SUNDRY NOTICES AND REPORTS ON WELLS
Do not use this form for proposals to drill or to re-enter an abandoned well. Use Form 3160-3 (APD) for such proposals.

8. Well Name and No.
Parke No. 001

9. API Well No.
30-015-04060

Tandem Energy Corporation
Parke No. 001 (API 30-015-04060)
Square Lake Grayburg-San Andres
Eddy County, New Mexico
Proposed Plugged Wellbore

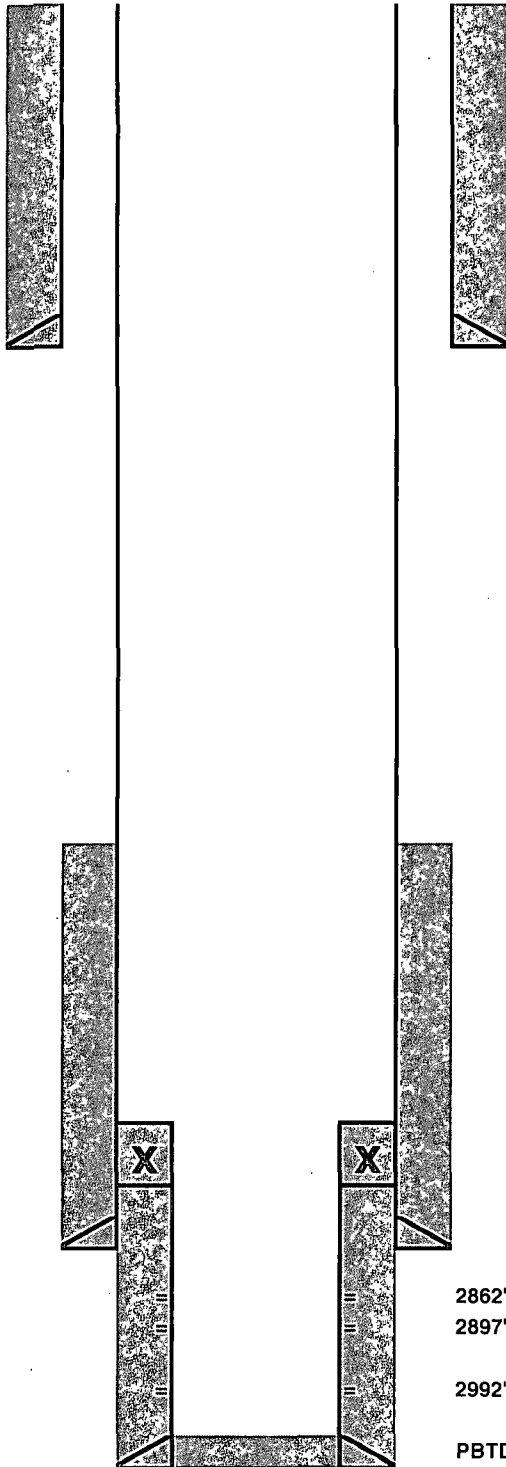
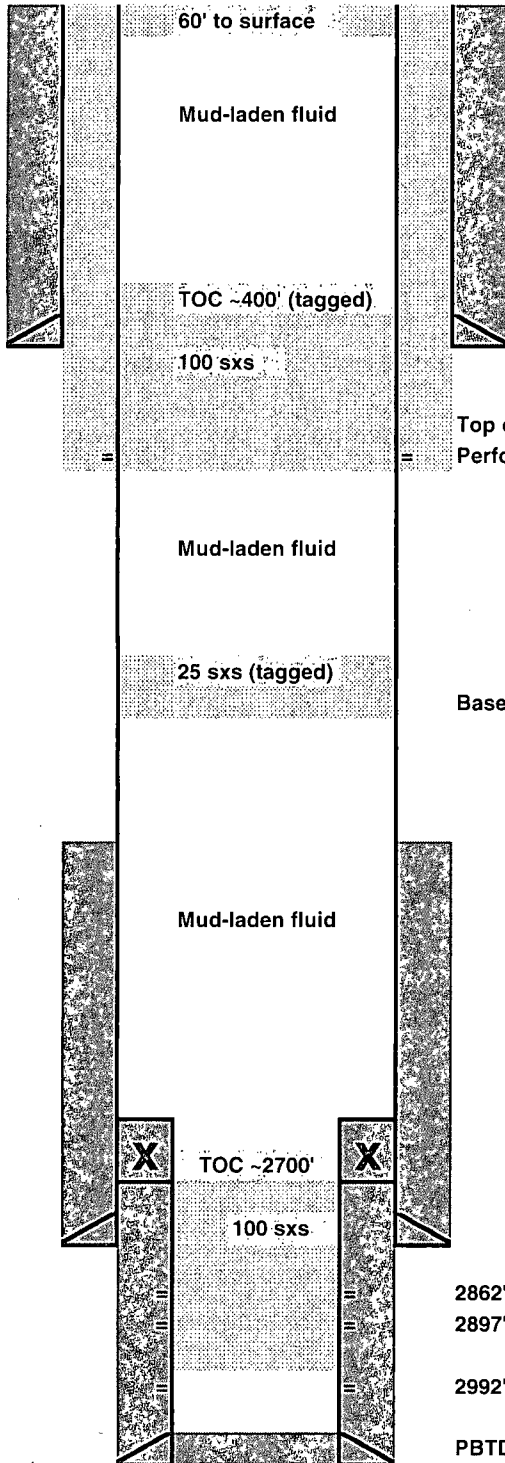
1. Pump 100 sacks of cement and displace to perforations with mud-laden fluid for an estimated top of cement at 2700'. *Perforate @ 1310' SQZ cut to 1210' 2650. WOC Tag*
